UNITED STATES
NUCLEAR REGULATORY COMMISSION
OFFICE OF INSPECTION AND ENFORCEMENT
WASHINGTON, D.C. 20555

IE Bulletin No. 80-16

POTENTIAL MISAPPLICATION OF ROSEMOUNT INC. MODELS 1151 AND 1152 PRESSURE TRANSMITTERS WITH EITHER "A" OR "D" OUTPUT CODES

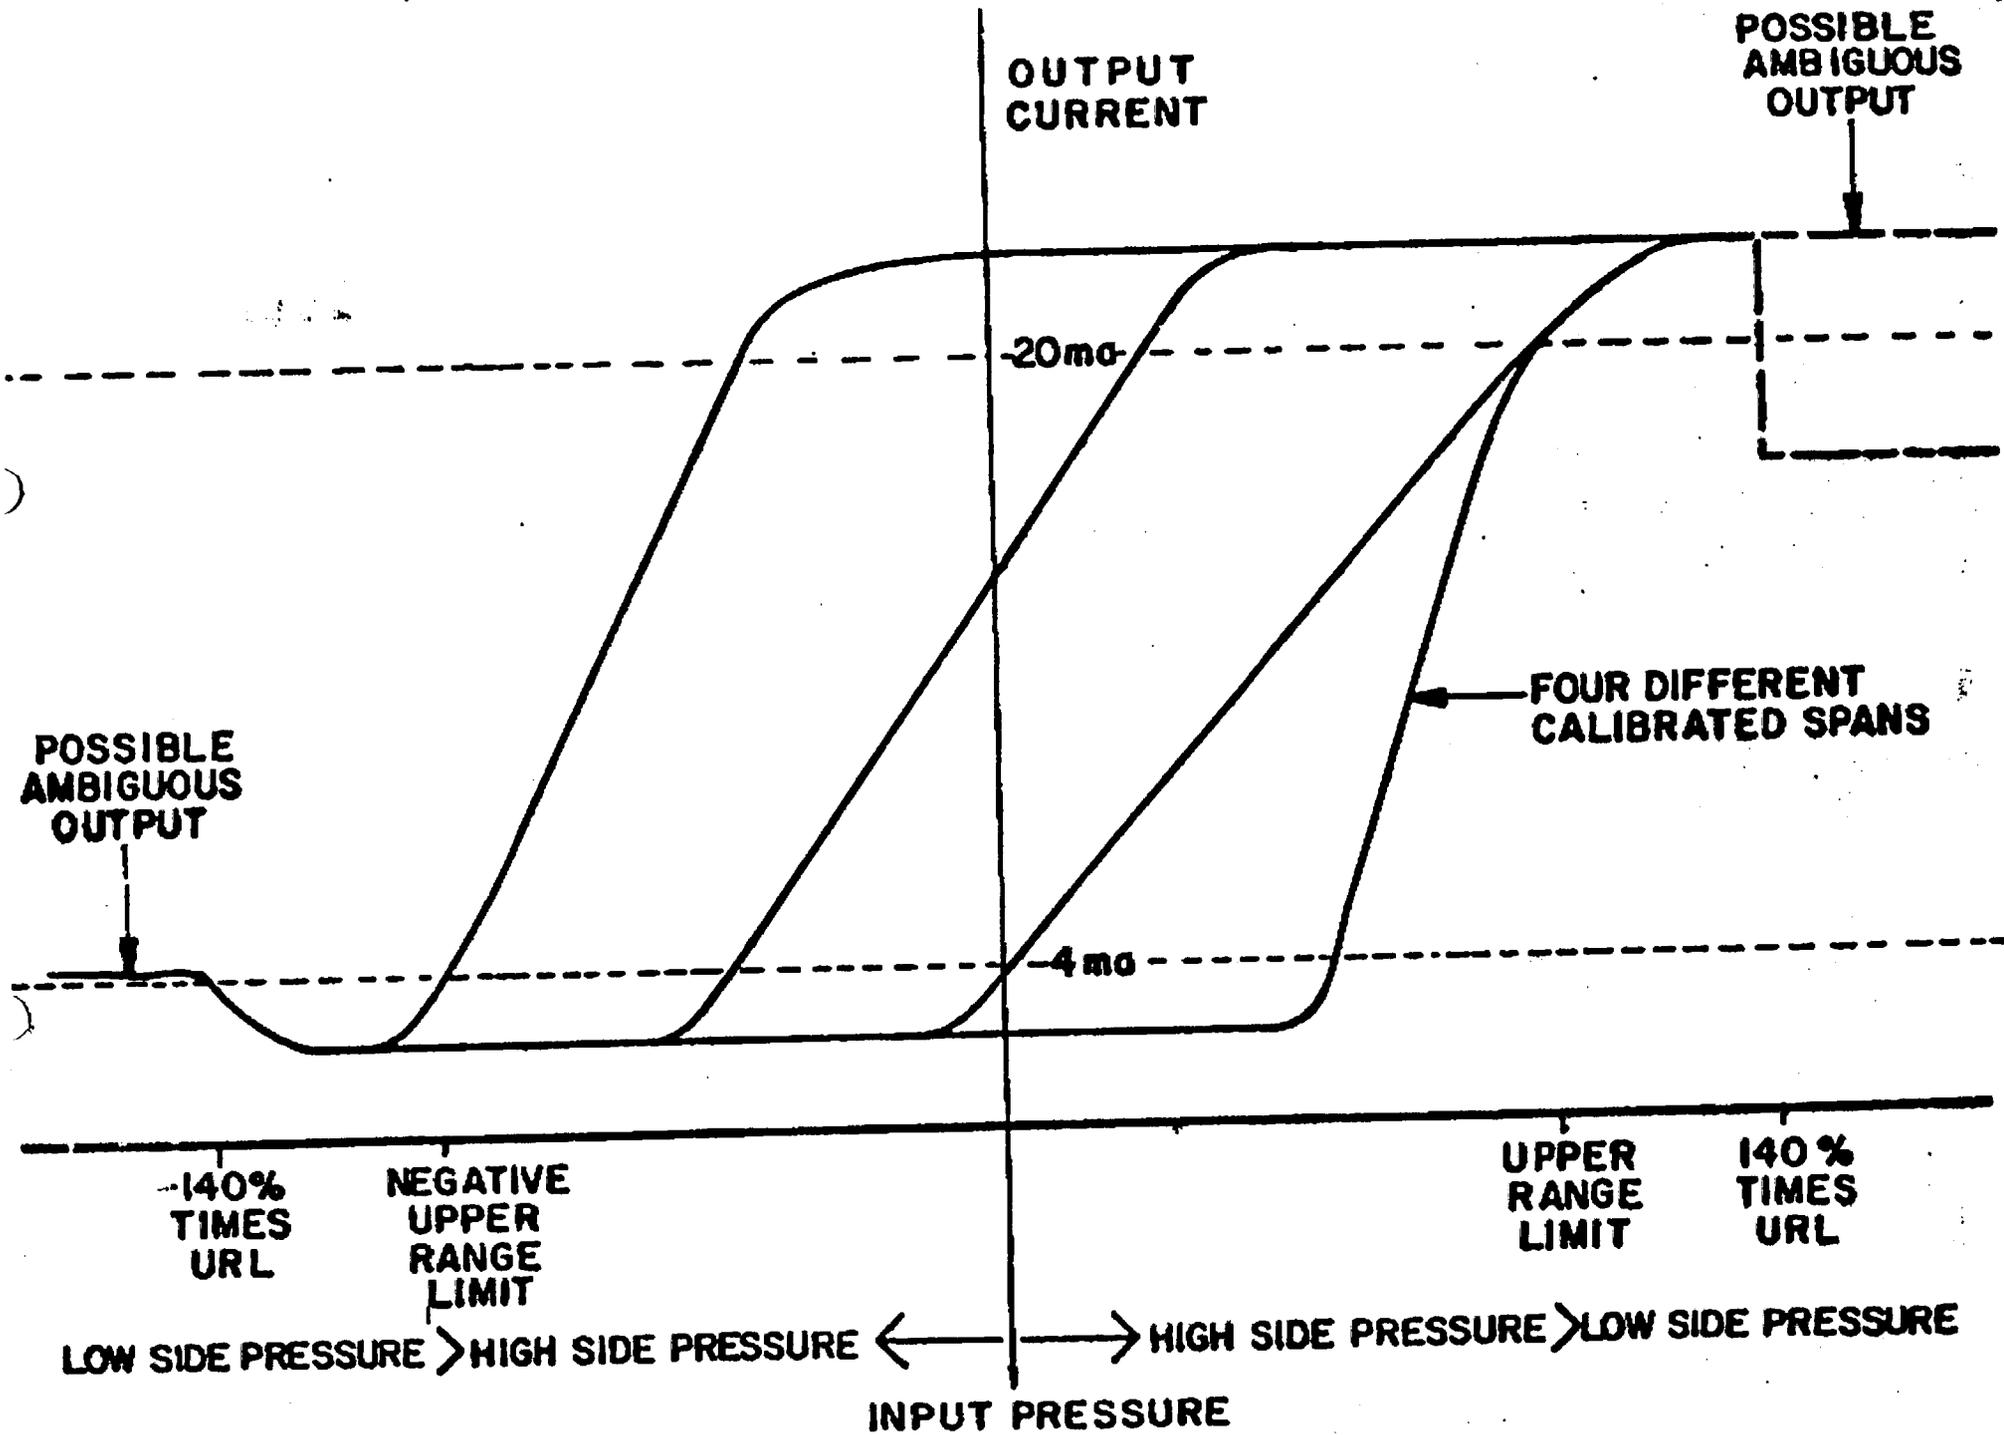
Enclosure 1 contains Rosemount Inc.'s technical description of the potential application problems for Pressure Transmitters Model 1152. This information is applicable to Model 1151 Pressure Transmitters also. This information includes the reasons for the maloperation of the transmitters, a typical pressure versus current output curve and examples of the results of the maloperations. Available information indicates that the problem was reported to each customer who was furnished the subject transmitters by Rosemount Inc.

For the over pressure condition, the effect of the high capacitance from the sensor is a modulated output on the oscillator circuit which may cause the output current of the transmitter to drop below 20 mA. In a limited sample size, the ambiguous output during this over pressure condition occurred in 5% of the transmitters at ambient conditions. Referring to the attached graph, this does not occur until the over pressure condition is $\geq 140\%$ of the upper range limit regardless of span. At that point a discontinuity can occur with the output current instantaneously decreasing to less than 20 mA. As an example of this potential applications problem, the upper range limit of a range 5 1152 differential pressure transmitter (Model 1152DP5A22) is 750" H₂O. The range of this pressure transmitter can be set from 0 to 150" H₂O. If the ambiguous output in the over pressure condition is to occur, it will occur at 140% or more of the upper range limit or, in this case, at pressures ≥ 1050 " H₂O (750" H₂O x 1.4). The transmitter then could give an output less than 20 mA at a pressure that is, in this example, seven

times ($1050''\text{H}_2\text{O} \div 150''\text{H}_2\text{O}$) the upper range value. Note that the significant figure for use in determining the pressure above which an ambiguous output can occur is the specified upper range limit ($750''\text{H}_2\text{O}$ in this example) not the customer selected upper range value ($150''\text{H}_2\text{O}$ in this example).

For the reverse pressure condition, the effect of the high capacitance from the sensor is the oscillator circuit drawing more current which may cause the output current of the transmitter to exceed 4 mA. In a limited sample size, the ambiguous output during this reverse pressure condition occurred in 55% of the transmitters at ambient conditions. Referring to the attached graph, this does not occur until the reverse pressure condition exceeds 140% of the upper range limit regardless of the span. At this point the output may exceed 4 mA. As an example of this potential applications problem consider the range 5 differential transmitter in the previous paragraph. If the ambiguous output in the reverse pressure condition is to occur, it will occur at 140% or more of the upper range limit, or in this case at reversed pressures $> 1050''\text{H}_2\text{O}$ ($750''\text{H}_2\text{O} \times 1.4$). The transmitter then could give an output greater than 4 mA at a pressure that is, in this example, seven times ($1050''\text{H}_2\text{O} \div 150''\text{H}_2\text{O}$) the upper range value, but reversed. Also note that with absolute pressure units a reverse pressure is not possible since the low pressure side of the cell is evacuated. With gage units a reverse pressure is possible only if a vacuum is present on the connected part since the low pressure side of the cell is vented to ambient atmosphere. Since the maximum reverse pressure would be one atmosphere, only range 3 and 4 gage units could obtain a reverse pressure exceeding 140% of the upper range limit.

The safety system should be analyzed in view of this supplementary report to determine if a potential application problem exists and appropriate corrections to the safety system should be implemented.
